MIL-PRF-19500/542K
w/AMENDMENT 2
30 June 2026
SUPERSEDING
MIL-PRF-19500/542K
w/AMENDMENT 1
4 March 2021

PERFORMANCE SPECIFICATION SHEET

TRANSISTOR, FIELD EFFECT, N-CHANNEL,
SILICON, ENCAPSULATED (THROUGH HOLE PACKAGE),
TYPES 2N6756, 2N6758, 2N6760, 2N6762, JAN, JANTX, JANTXV, JANS, JANHC, AND JANKC

FIGURE 1. Physical dimensions of transistor (TO-204AA).

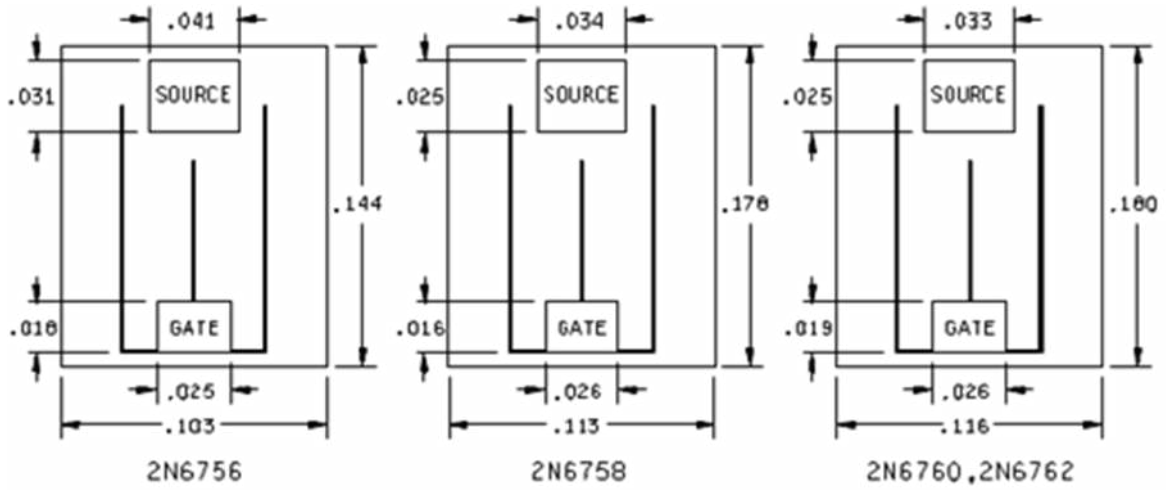
*NOTES:
1. Dimensions are in inches.
2. Millimeters are given for general information only.
3. These dimensions should be measured at points .050 inch (1.27 mm) and .055 inch (1.40 mm) below seating plane. When gauge is not used measurement will be made at the seating plane.
4. The seating plane of the header shall be flat within .001 inch (0.03 mm) concave to .004 inch (0.10 mm) convex inside a .930 inch (23.62 mm) diameter circle on the center of the header and flat within .001 inch (0.03 mm) concave to .006 inch (0.15 mm) convex overall.
5. Mounting holes shall be deburred on the seating plane side.
6. Drain is electrically connected to the case.

FIGURE 2. JANHCA and JANKCA (A-version).

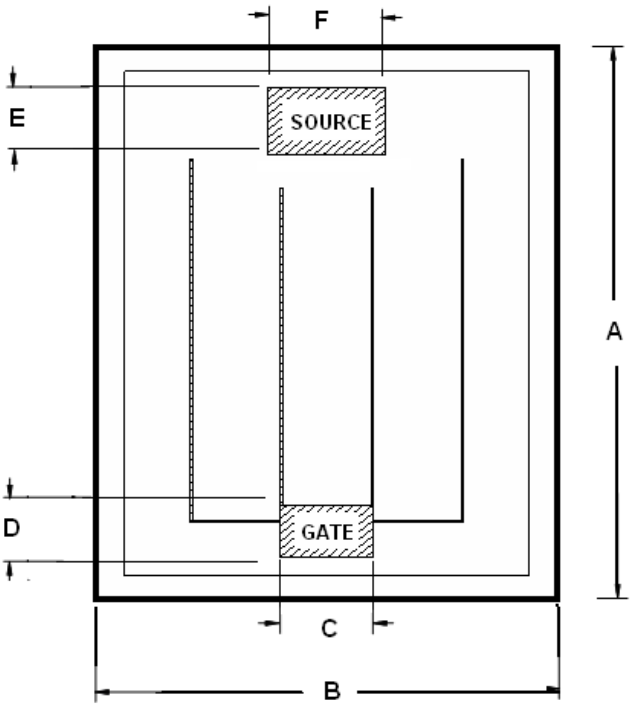
* NOTES:
1. Dimensions are in inches.
2. Millimeters are given for general information only.
3. Unless otherwise specified, tolerance is .005 inch (0.13 mm).
4. The physical characteristics of the die thickness are .0187 inch (0.475 mm). The back metals are chromium, nickel and silver. The top metal is aluminum and the back contact is the drain.

* FIGURE 4. JANHCD and JANKCD (D-version) die dimensions for 2N6756, 2N6758.

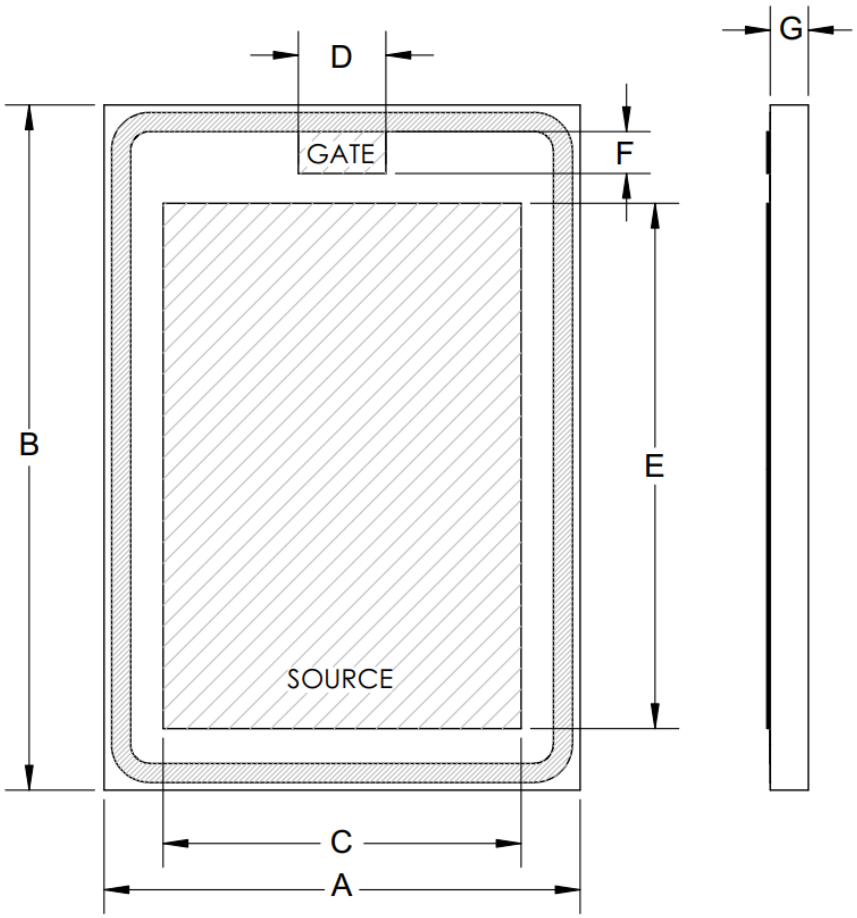
* 1.2 Package outlines. The device package outlines are as follows: TO-204AA; formerly TO-3 in accordance with figure 1 for all encapsulated device types. See figures 2 and 3, and 4 for unencapsulated devices.

* 1.5.5 Die identifiers for unencapsulated devices (manufacturers and critical interface identifiers). The manufacturer die identifiers that are applicable for this specification sheet are "A", "C", and "D" (see figures 2, 3, 4 and 6.6).

* 3.4 Interface and physical dimensions. Interface and physical dimensions shall be as specified in MIL-PRF-19500, and on figure 1 (TO-204AA; formerly TO-3), figures 2, and 3, and 4 for JANHC and JANKC die dimensions.

* e. For die acquisition, the JANHC or JANKC letter version shall be specified (see figures 2, 3, and 4).
